To: All Subaru Retailers
From: Subaru of America, Inc. – Service
Date: July 2, 2018
Re: *Harman Gen 3 Audio and Navi Head Unit update - In-stock Vehicles*

NUMBER: 15-211-17R
DATE: 06/13/17
REVISED: 07/25/18

SUBJECT: Reprogramming File Availability for Additional Optimization of Harman Gen 3 Audio and Navigation Head Units

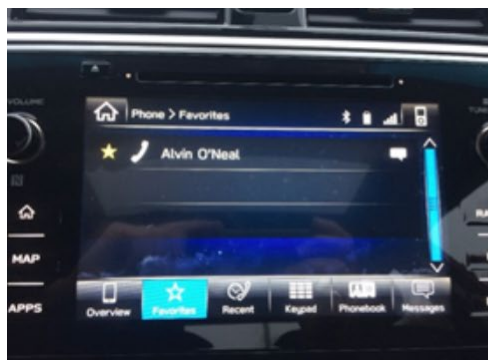
- Corrects for condition where only the star field background is displayed (without icons) after the HOME button is pressed.

Background shown, but no icons

Normal HOME screen with icons

List is blank

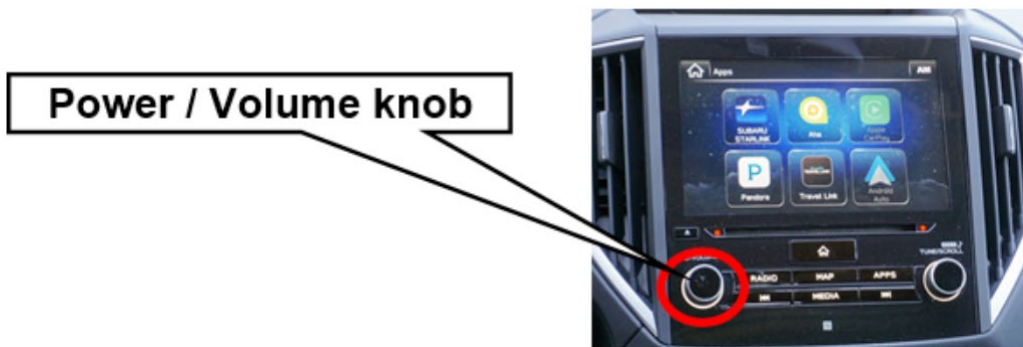
- Corrects for a “Pop” or “Crackling“ sound concern when listening to AM radio.
- Corrects for a concern of the head unit continually resetting itself.
- Corrects for a concern of after selecting a contact to be a “Favorite” and the “Favorite” list display is blank.

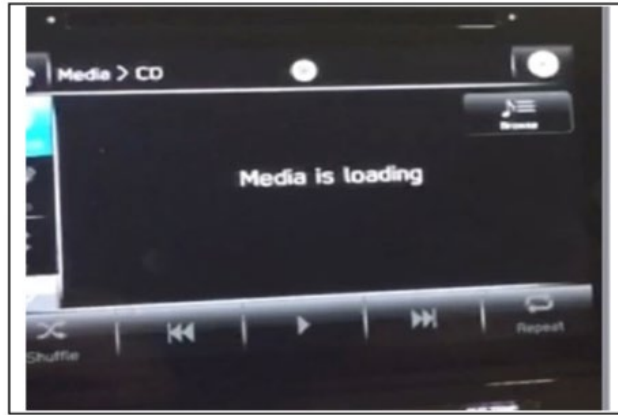
- An enhancement of Voice Recognition feature has been made for improved HVAC system interface and recognition of temperatures requested in Fahrenheit instead of Celsius. **EXAMPLE:** “Set temperature to 75.” With the previous version, the system interpreted “75” as degrees Celsius which would have been 167 degrees Fahrenheit and outside system parameters. As a result, there was no response from the HVAC system.
